TECHNICAL EVALUATION REPORT
TECHNICAL BASIS FOR REDUCTION OF TORUS SHELL
CONDENSATION OSCILLATION LOADS FOR THE
NIAGARA MOHAWK POWER CORPORATION
NINE MILE POINT UNIT 1

*January 1994
Revised May 1994*

*Office of Nuclear Reactor Regulation
Nuclear Regulatory Commission
Washington, D.C. 20555*

Figure 1-BNL Method of Images Predicted Variation of Pressure in the Computation Cell Plane of Symmetry- $\bar{P}(X, 0, Z_0/2)$

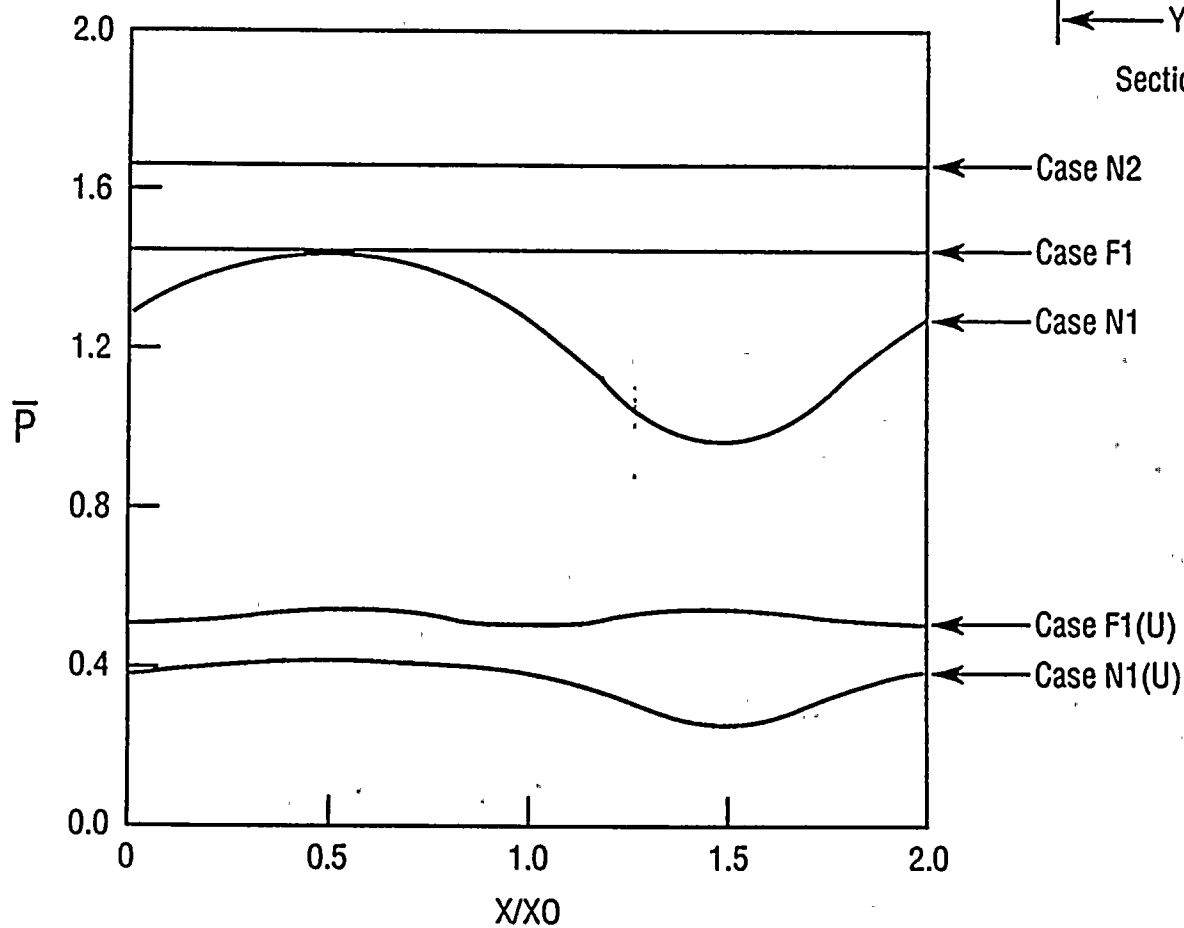
Referring now to Figure 1, the most significant of the results shown there is the large reduction in pressure that is obtained when the sources are no longer correlated. Even for the FSTF, the pressures are reduced to only about one third of the correlated values. Interestingly enough, this is more or less the order of magnitude of reduction in pressure amplitude between the fundamental frequency (about 3 psi for 5 Hz) and the other non-synchronous values (1 psi maximum) as indicated in Table 4.4.1-2 of Reference 1.

Figure 2- Comparison of BNL and NMPC Estimates for Pressure Amplitude Reduction Factors

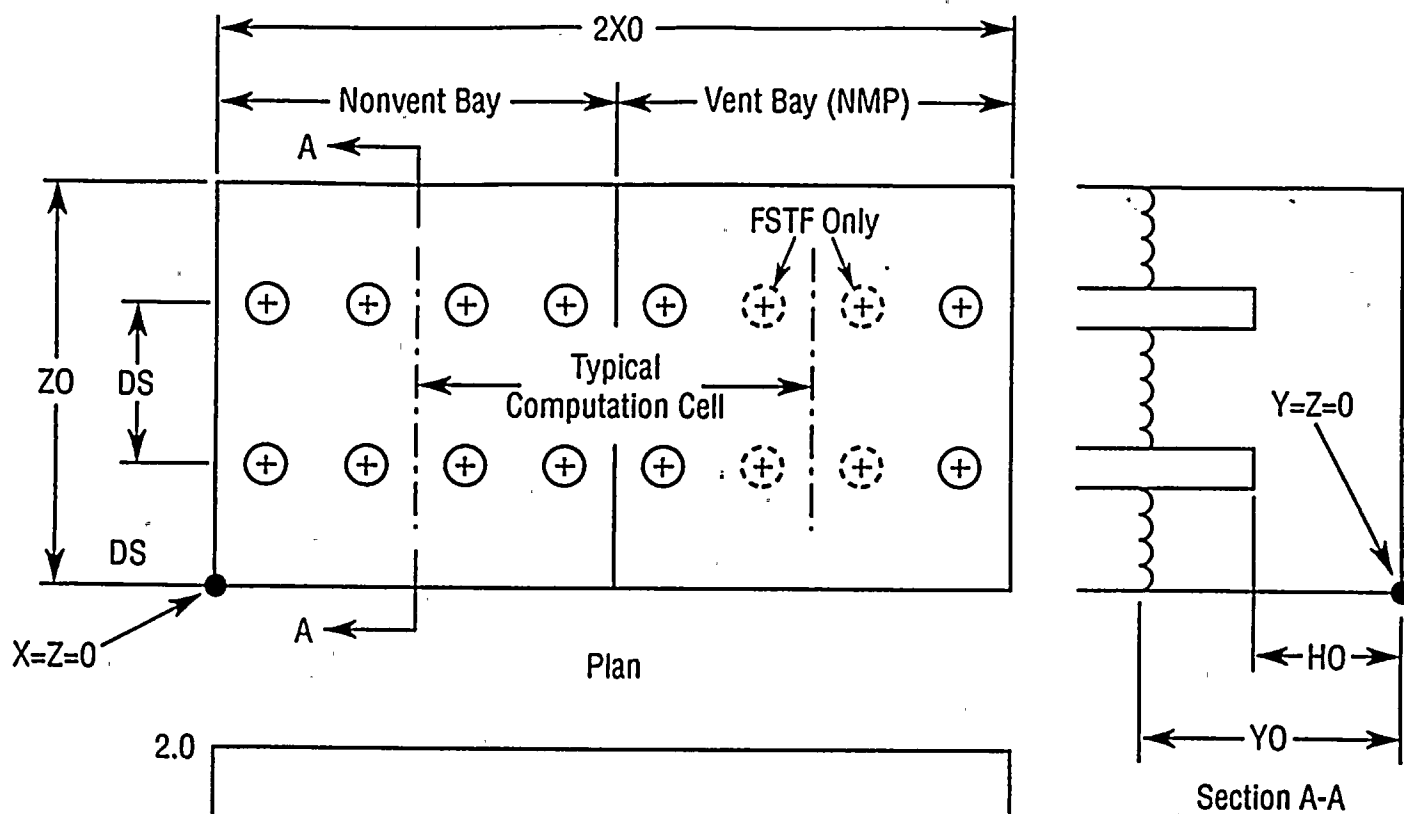
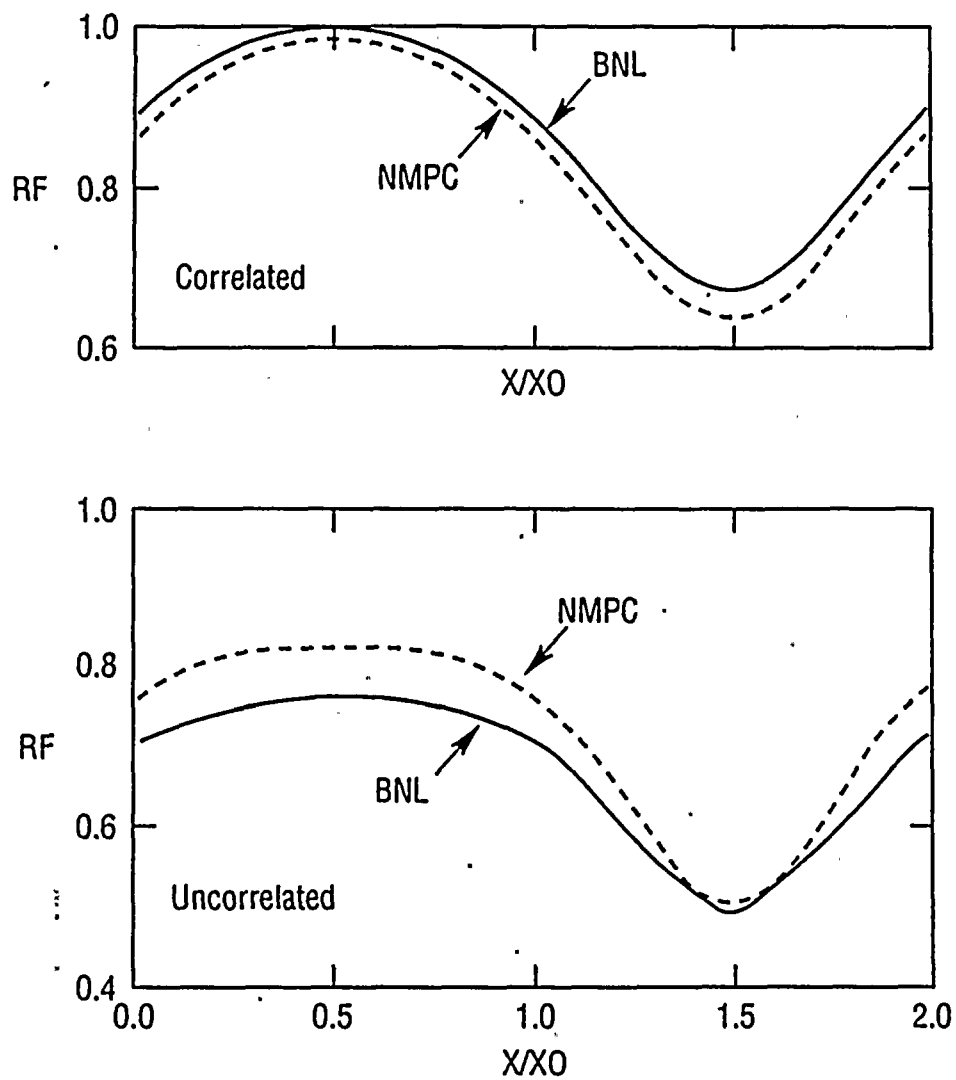
Comparison of the BNL and NMPC values of the RFs shown in Figure 2 indicate clearly that they are in very good agreement. Note especially that the NMPC's uncorrelated RFs are more conservative than BNL's. That is, the LDR pressure amplitudes are reduced less when the NMPC RF's are used. Some nonconservatism is exhibited for correlated RF's but this difference is, at most, 6%. These differences are considered minor and, in our judgement, do not invalidate the acceptability of the proposed modifications.

Figure 3- Results of Sensitivity Studies for NMP via the BNL Method of Images

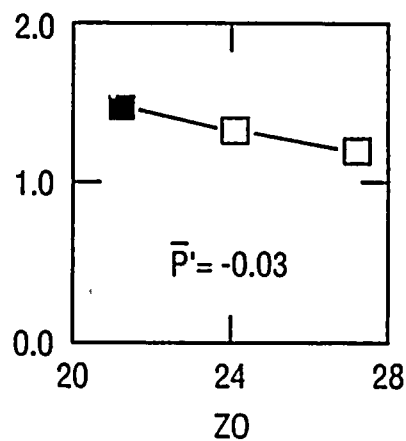
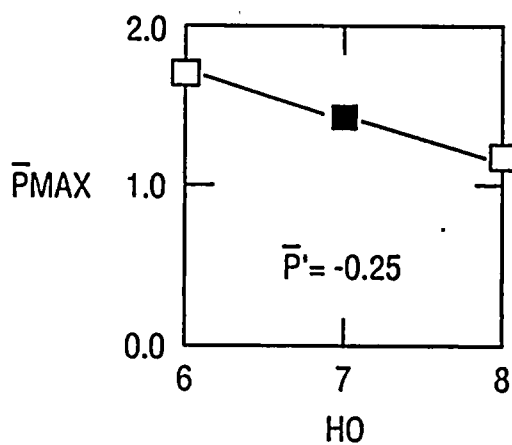
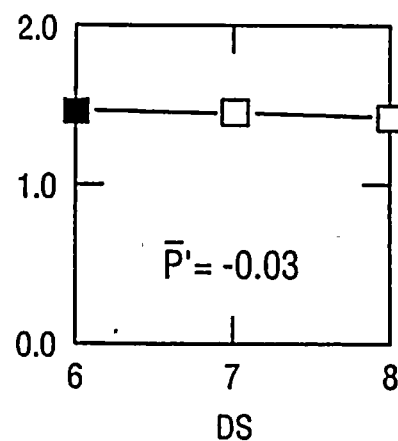
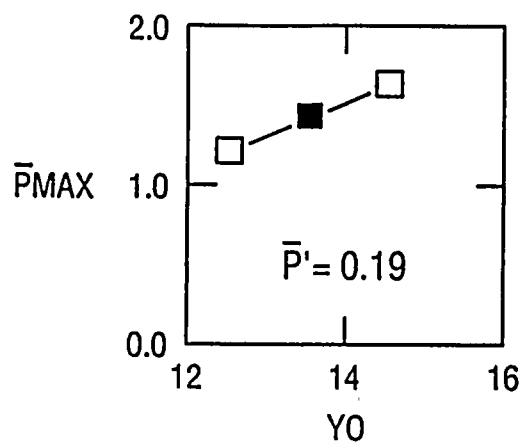
With respect to the sensitivity studies that were performed, we note first that they were motivated by the result obtained for Case N2 of Table 2 corresponding to a computational cell with the NMP geometry but with four rather than three pairs of downcomers. Although

As can be seen by referring to Table 2, the value of P_{MAX} corresponding to Case N2 (1.66) not only exceeds that for Case N1 (1.45), which is to be expected, but also exceeds the value predicted for the basic FSTF case (Case F1). This increase can only be attributed to geometric differences since source number and strength are identical for those two cases. The same sort of difference is exhibited between the Case F2 (P_{MAX} = 1.24) and the Case N1 (P_{MAX} = 1.45) results. Note that these latter two cases correspond to 8-4-8-4 type configurations. These findings were the motivation for the sensitivity studies that were conducted; ie: to determine what feature of the NMP torus geometry gives rise to pressure loads higher than those expected in the FSTF for the same number of downcomers. As can be seen from the results shown in Figure 3, the noted increases are primarily the result of the significantly smaller clearance (7 vs 7.8 ft) that prevails in the NMP torus. One implication of this finding is that the FSTF geometry was not strictly applicable for NMP both with respect to the latter's 8-4-8 downcomer arrangement (a conservatism), but also with regard to downcomer clearance (a non-conservatism). The trade-off between these two opposing effects suggests that the original NMP design loads were suitable, notwithstanding that, to the authors' knowledge, no adjustment for the effect of reduced clearance was made or considered.

A more positive interpretation of this finding would be that CO loads could be reduced by an increase in clearance at NMP; ie: by shortening the length of the downcomers. According to Table 2 (Case N8 vs Case N1), a decrease in P_{MAX} of almost 20% could be achieved by removing 12 inches from the downcomer ends. Of course, such a modification would involve significant expense but might be a cost-effective alternative to the structural modifications currently under consideration by NMPC in the event they become necessary. Note that a reduction of HO implies a corresponding reduction in downcomer submergence which tends to mitigate pool swell loads (Section 3 of Reference 3). However, it also potentially reduces the steam condensing performance of the suppression pool. Thus a total system analysis would be required to determine the merit of this concept.
